EXPOSITION PARK MASTER PLAN

FINAL SUBSEQUENT ENVIRONMENTAL IMPACT REPORT (EIR)
TO THE LOS ANGELES MEMORIAL COLISEUM RENOVATION PROJECT EIR
(STATE CLEARINGHOUSE No. 1990011065)

SEPTEMBER 21, 2020

SOURCE: Torti Gallas + Partners 2019

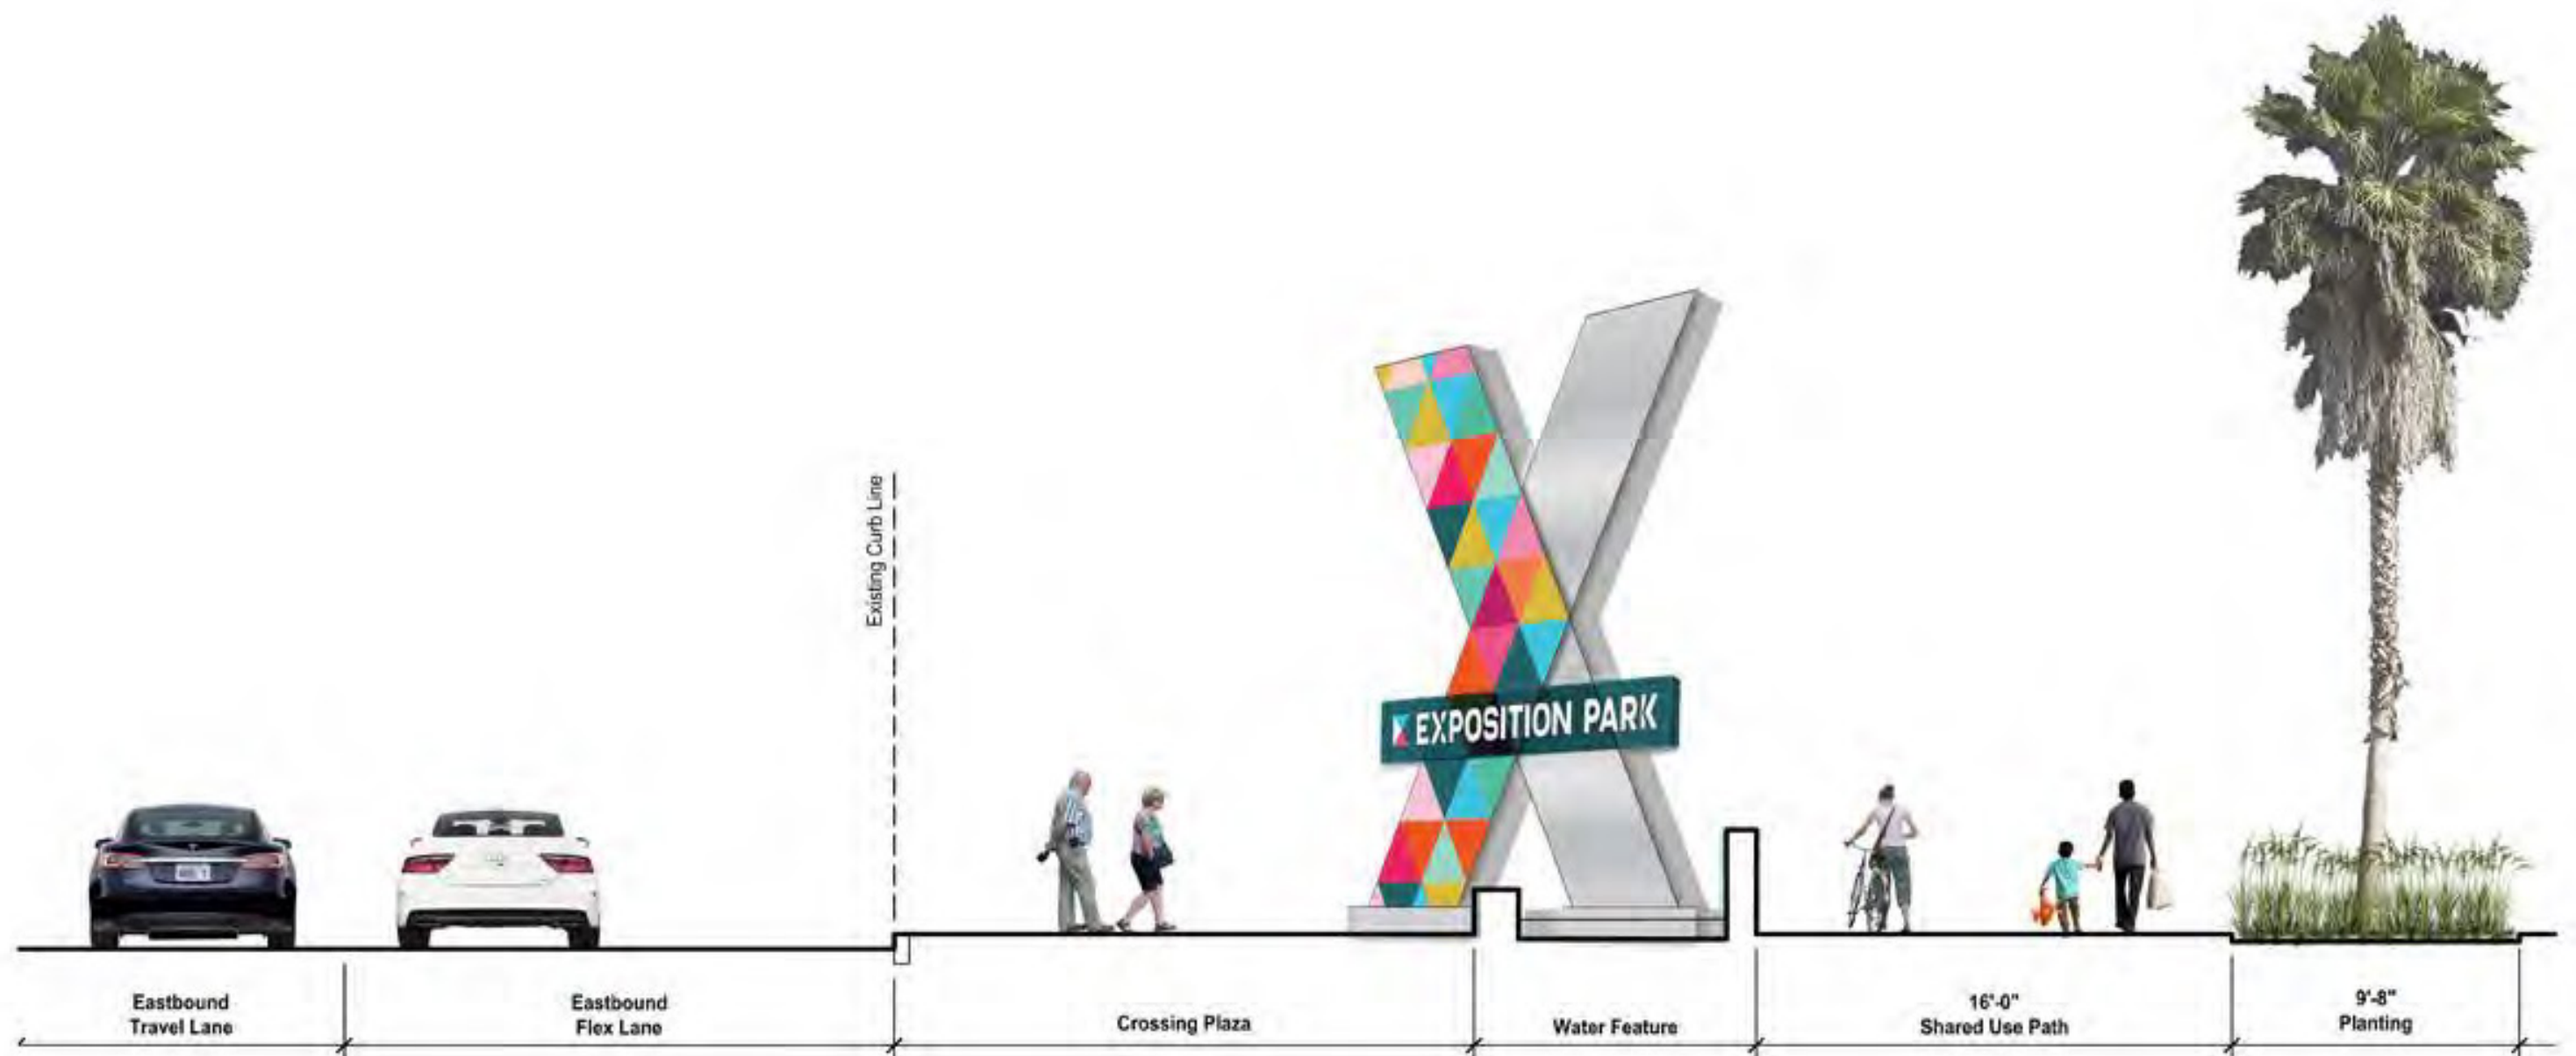
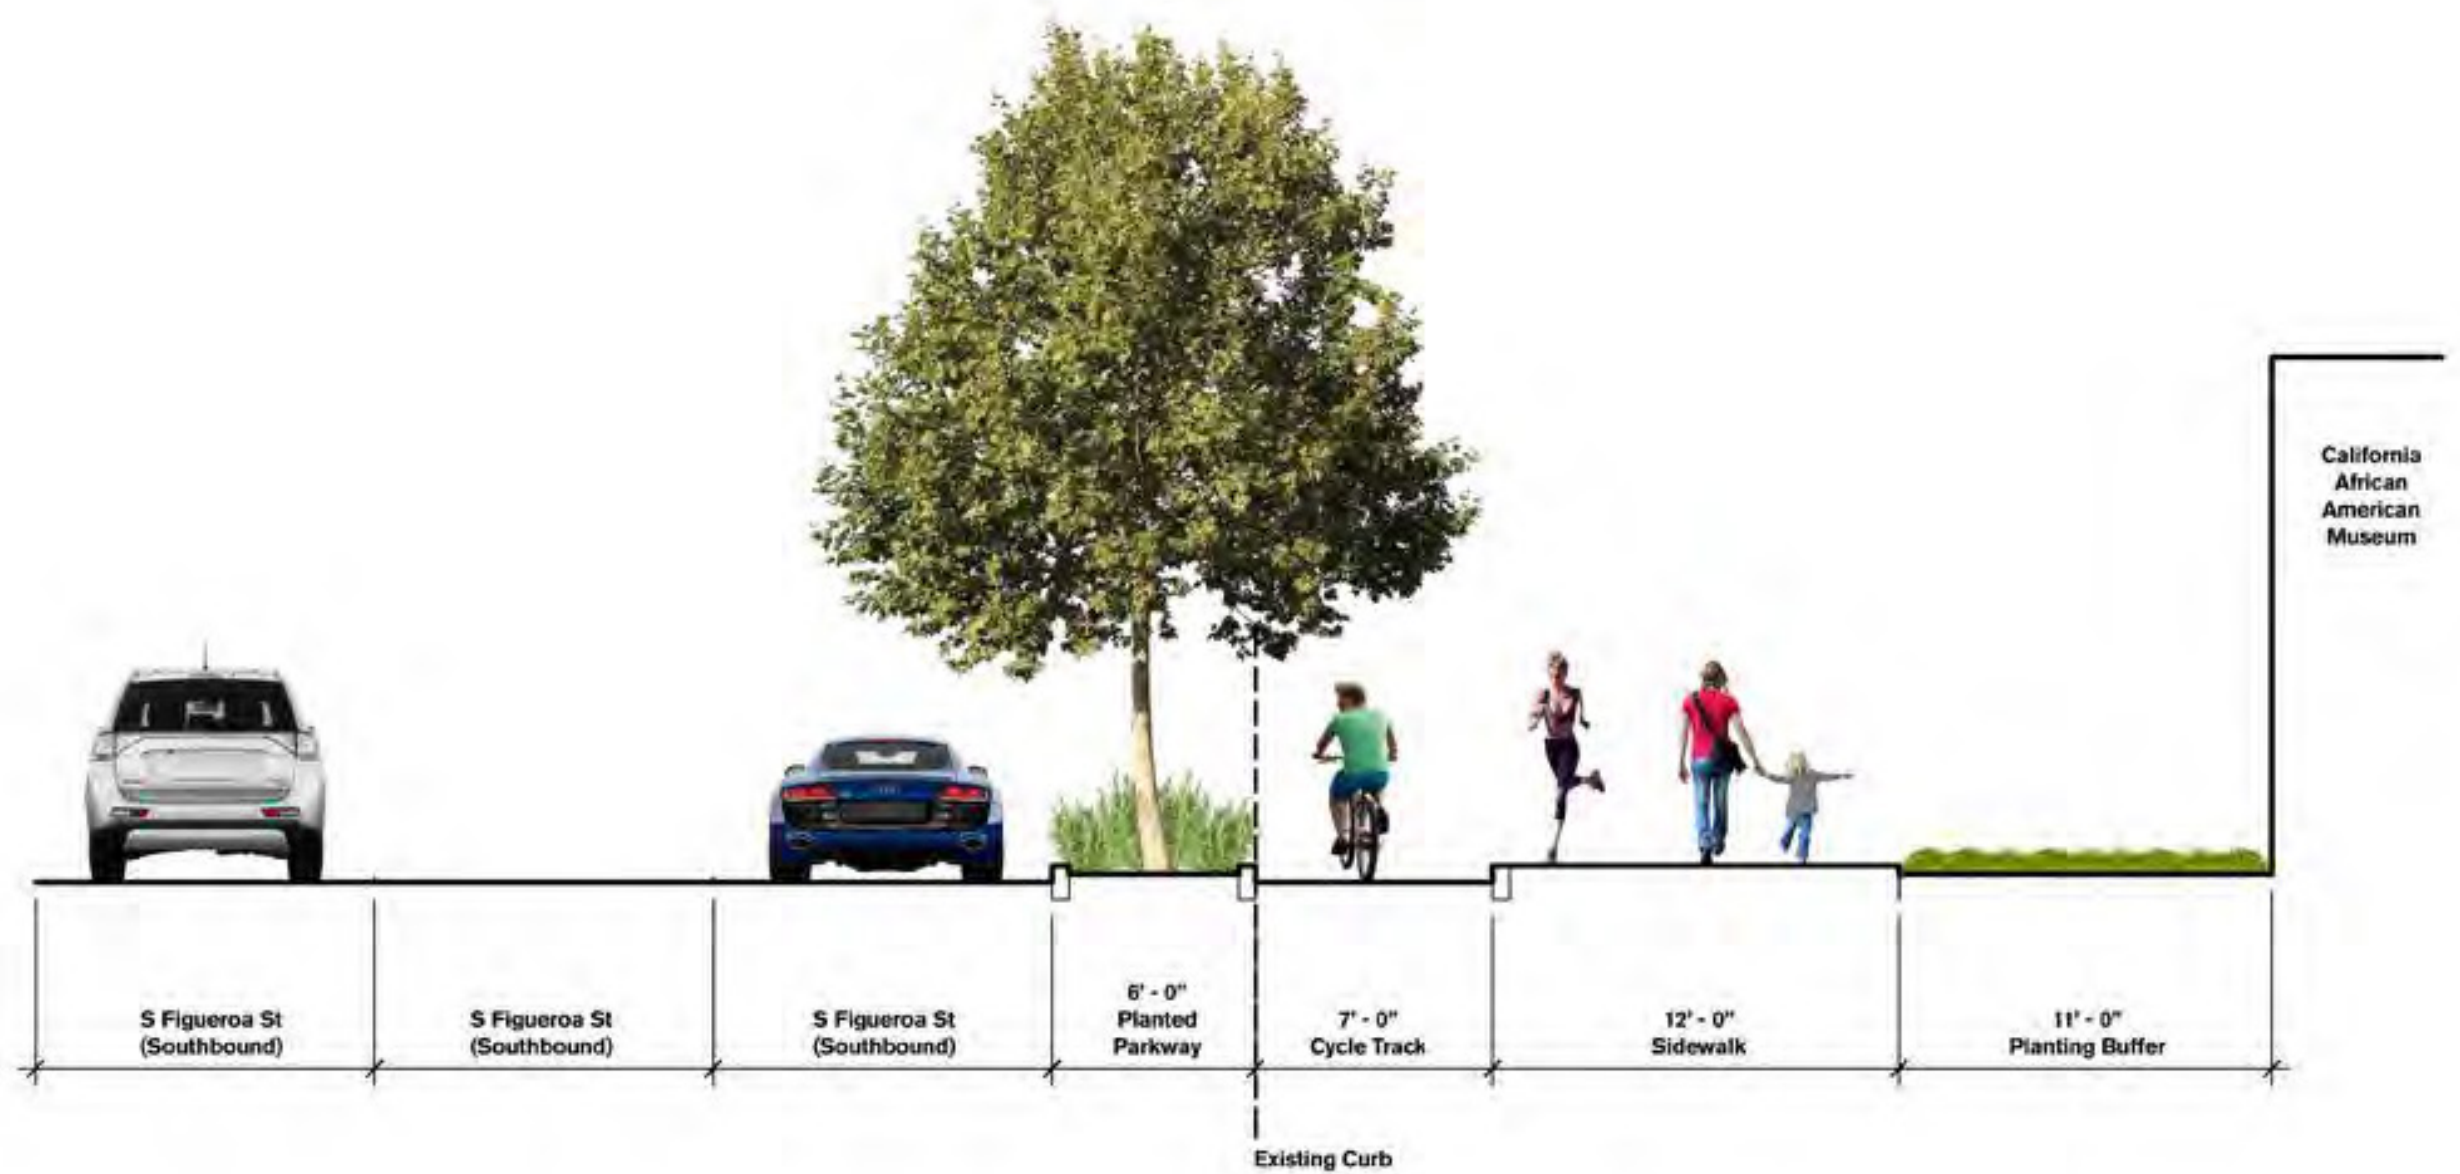
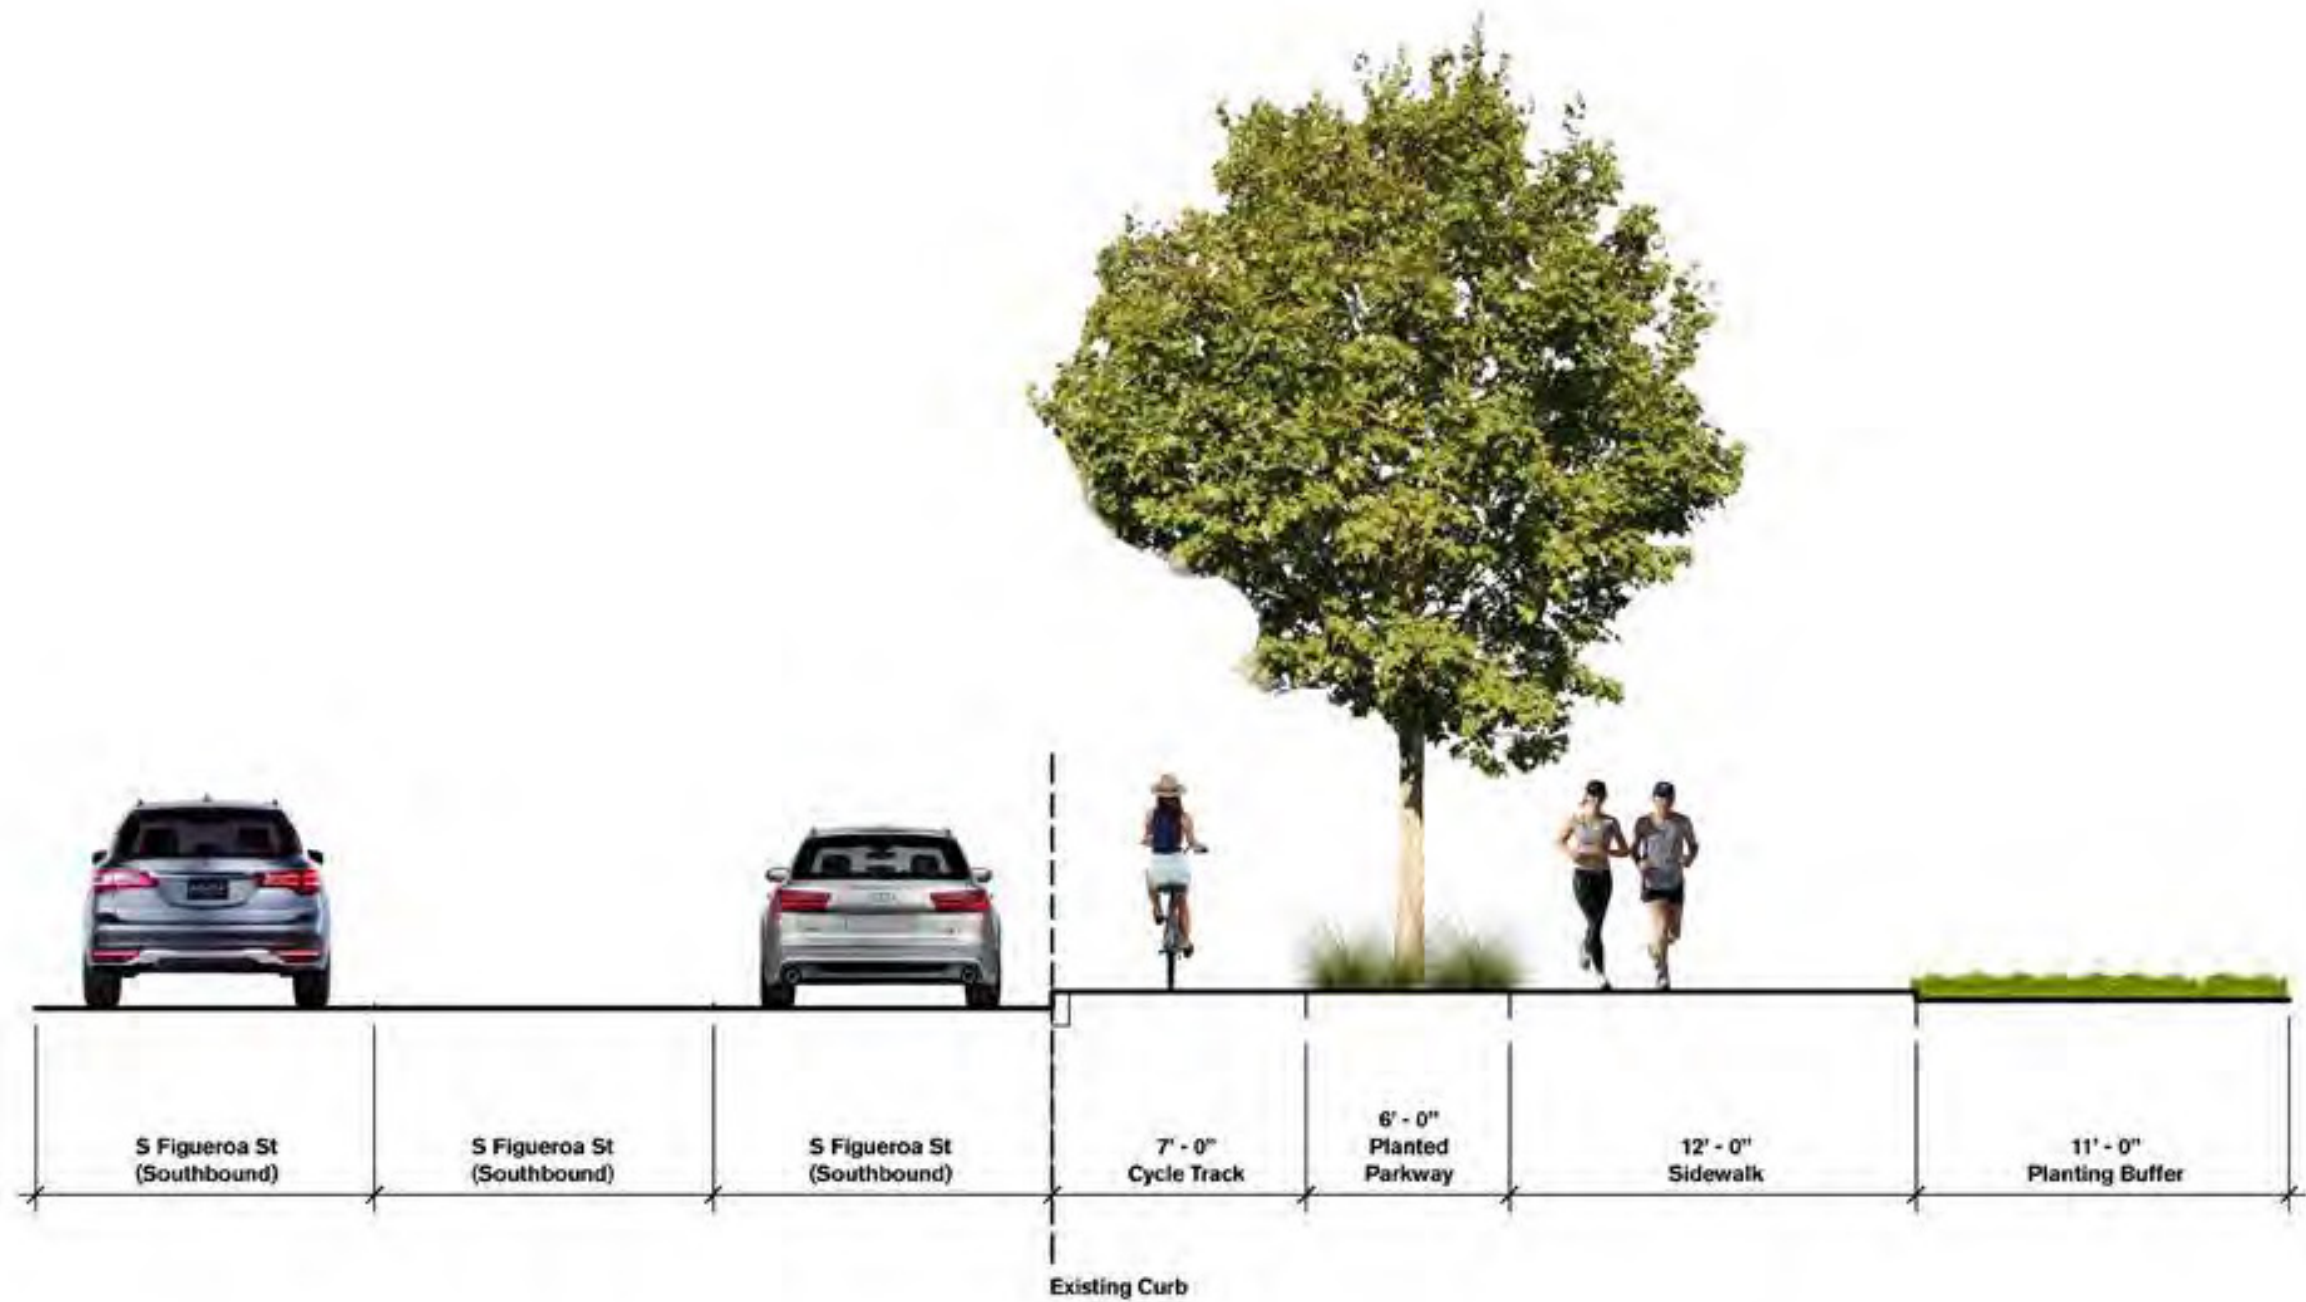
Page 2-10: Figure 2.4.1-1, *Master Plan Element 1 – Threshold and Gateway*, has been revised to provide further detail regarding the cycle track as well as safety issues on Kinsey Drive and State Drive.

FIGURE 2.7-1
 Approved Projects

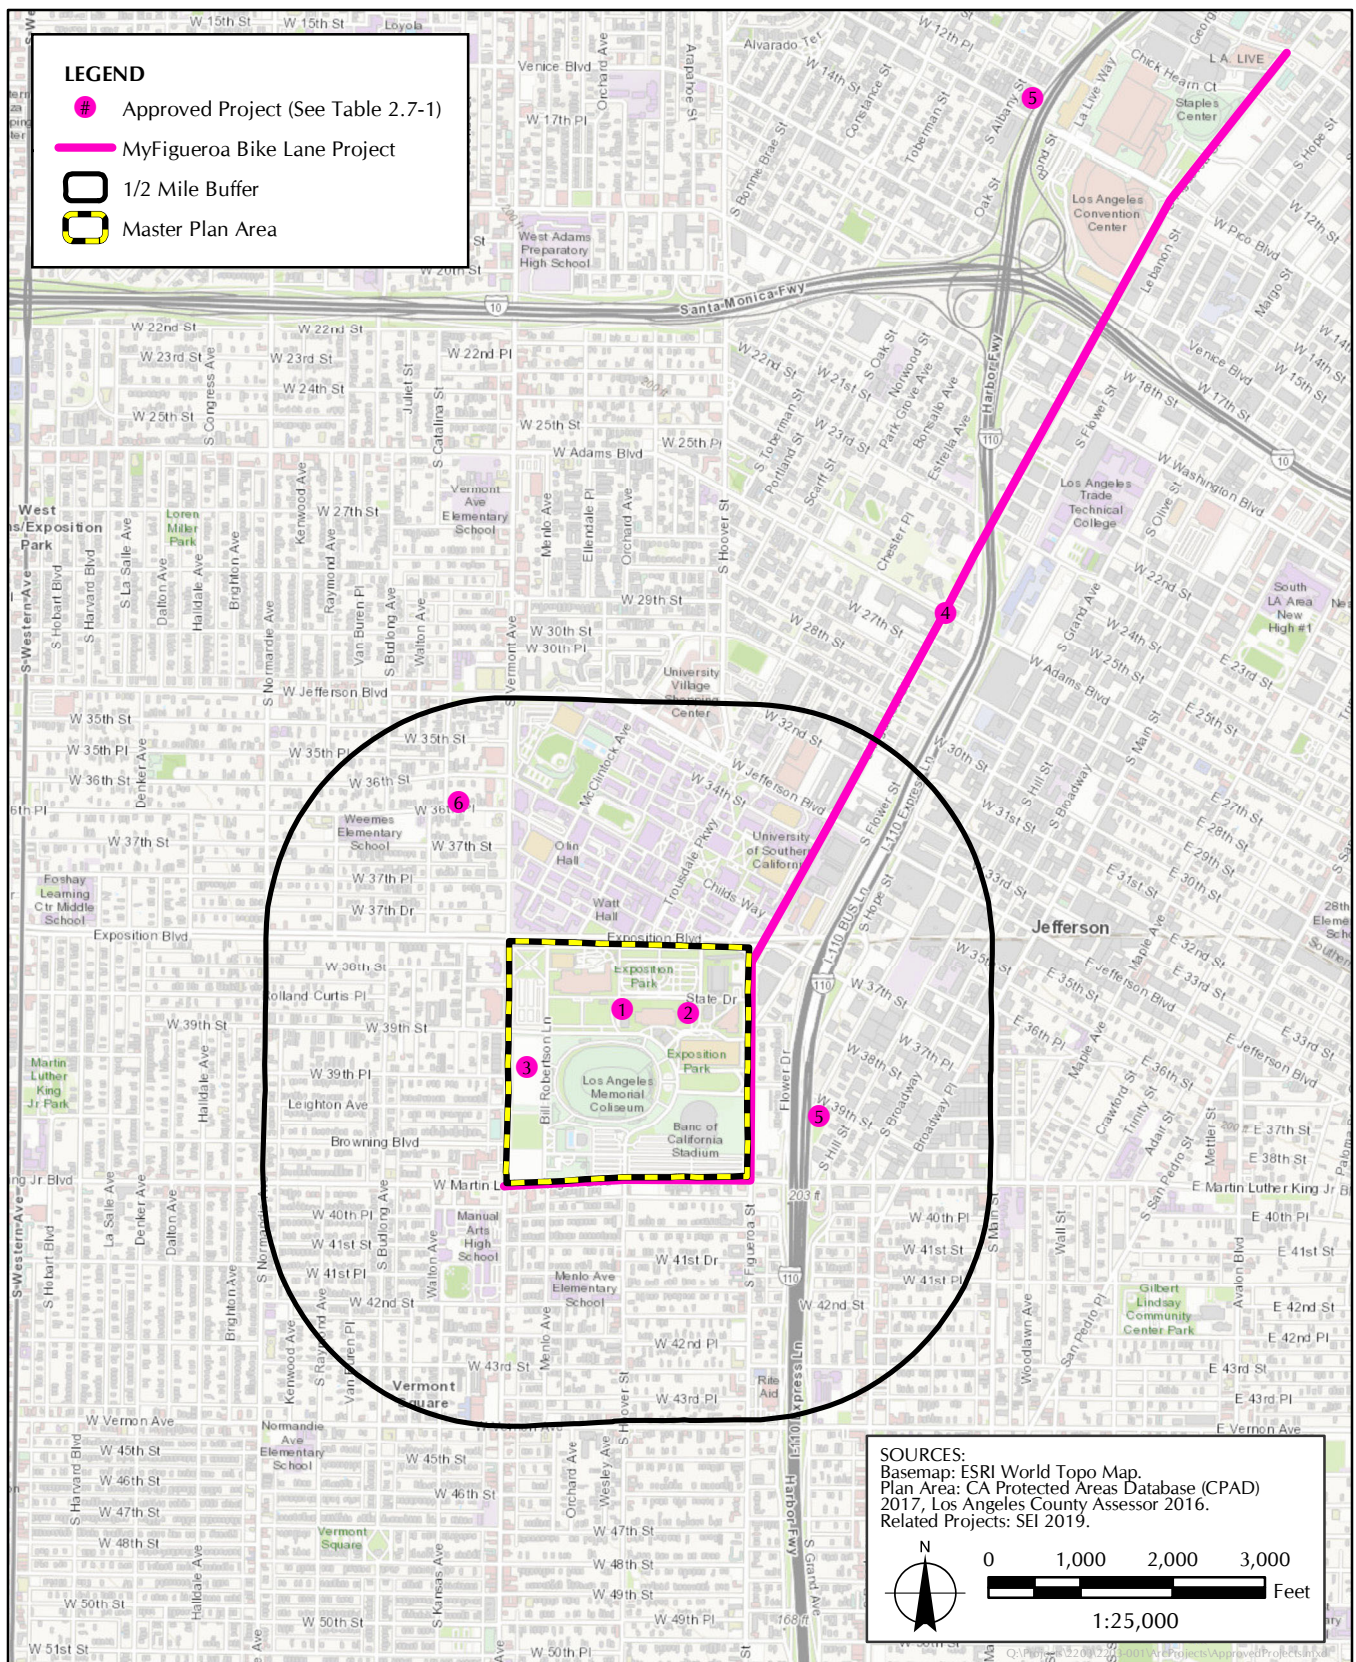
Page 2-26: Figure 2.7-1, *Approved Projects*, has been revised to clarify the location of related approved project no. 4.
